# Comments on Puget Sound Energy's 2017 Integrated Resource Plan

Washington Utilities and Transportation  
Commission Docket Nos. UE-160918 & UE-  
160919

**Prepared for Sierra Club**

January 19, 2018

Figure 1. Wind Capital Costs, Lazard Historical and PSE IRP Forecasts

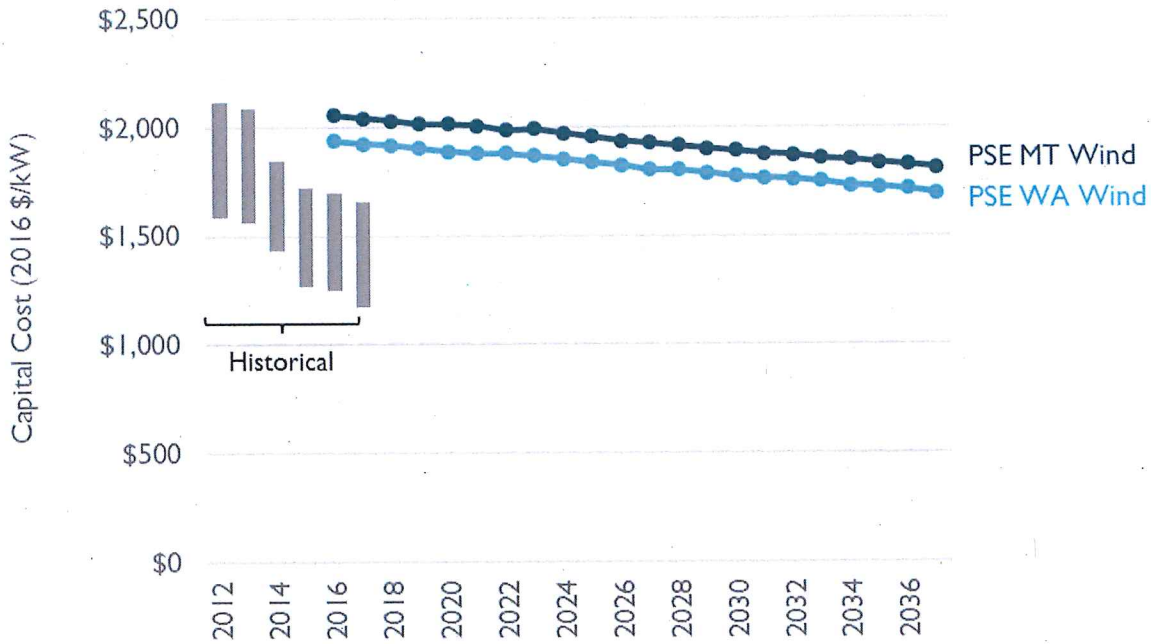
Figure 1 depicts PSE's forecasted capital costs for Washington and Montana wind in comparison to historical Lazard capital cost estimates. This shows that Lazard's estimates of 2017 wind capital costs are 15 percent lower than PSE's Washington wind assumptions and 23 percent lower than PSE's assumptions for Montana wind. Under PSE's projected trajectory, wind capital costs remain above currently achievable levels through 2037.

Figure 2. Solar Capital Costs, Lazard Historical and PSE IRP Forecasts

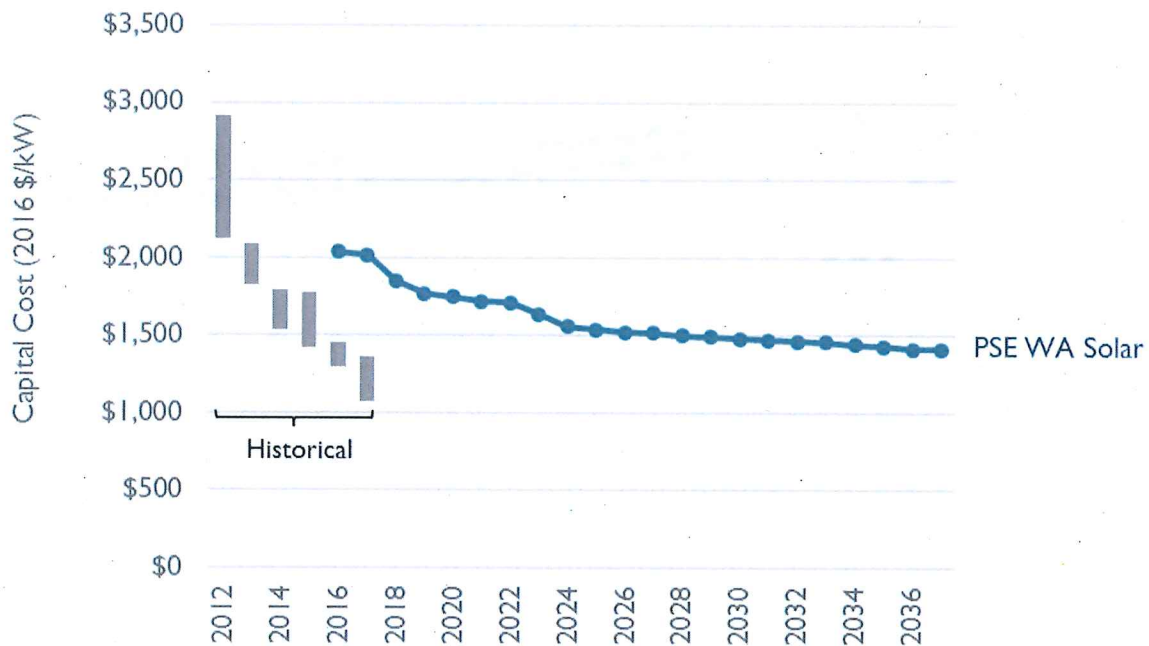
PSE’s solar cost assumptions appear to be even more overstated than its wind costs in the near term. Figure 2 shows that PSE’s cost estimates are about 50 percent too high for 2017. Although PSE forecasts future declines in solar costs, its projection still remains higher than Lazard’s estimate of current costs. Moreover, even PSE’s “lower” solar cost sensitivity assumes capital costs of \$1,755 per kilowatt (kW), about 30 percent higher than current capital costs per Lazard.<sup>21</sup>
